Project	IEEE 802.16 Broadband Wireless Access Working Group < http://ieee802.org/16 >	
Title	DL subchannelization for OFDM mode	
Date Submitted	2004-05-18	
Source(s)	Tal Kaitz et al. Alvarion Ltd. 21 A Habarzel St. P.O. Box 13139, Tel-Aviv 61131, Israel	Voice: +972-36457834 Fax: +972-36456222 mailto:tal.kaitz@alvarion.com
Re:	802.16e/D2 Letter Ballot	
Abstract	The document contains Sponsor Ballot comment information	
Purpose	The document is contributed to support certain comment on 802.16REVd/D4 Sponsor Ballot	
Notice	This document has been prepared to assist IEEE 802.16. It is offered as a basis for discussion and is not binding on the contributing individual(s) or organization(s). The material in this document is subject to change in form and content after further study. The contributor(s) reserve(s) the right to add, amend or withdraw material contained herein.	
Release	The contributor grants a free, irrevocable license to the IEEE to incorporate text contained in this contribution, and any modifications thereof, in the creation of an IEEE Standards publication; to copyright in the IEEE's name any IEEE Standards publication even though it may include portions of this contributio

Figure 3 Format of DL Subchannelization section

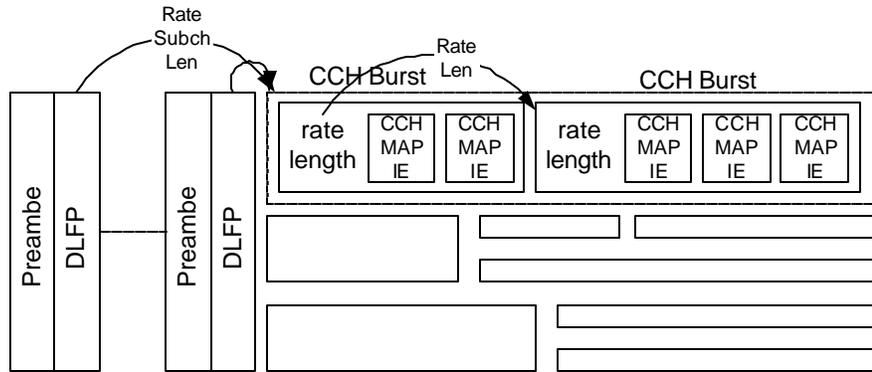
8.3.5.3 PMP DL subchannelization.

The DL sub-frame may optionally contain a DL subchannelization zone. This zone is marked by a DL_SUBCH_IE in the DL Map.

The DL subchannelization zone is shown in Figure 3. The zone commences with a short preamble. The preamble is followed by an FCH burst, which is one symbol long, occupies the entire BW, and is transmitted using QPSK rate $\frac{1}{8}$. The FCH is followed by

sub-channelized traffic. The data and pilot subcarrier allocations of the subchannelized traffic are defined in table 211 ('OFDM symbol parameters). One of the subchannels is designated as the control subchannel (CCH).

Figure 4 Map chaining

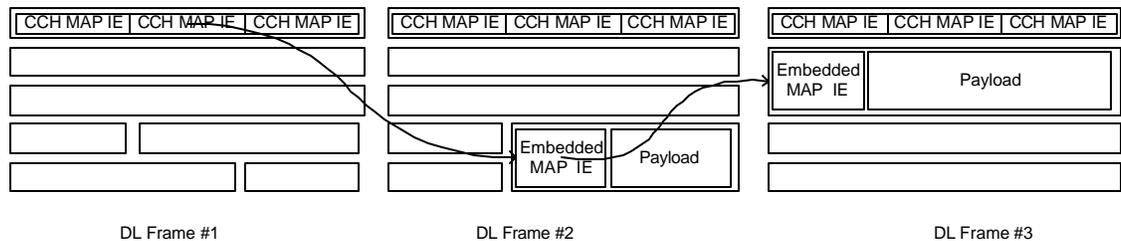
CCH_MAP_IE always points to a burst in the next frame. The pointed burst may contain an embedded map information element of similar structure, which points to a burst in the next frame. Thus a chain of maps is created. This is shown in Figure 4. Note that the CCH may be used to initiate such a chain of maps. The CCH_MAP_IE may echo the same information of the embedded information to help recover the chain in case of a channel error.
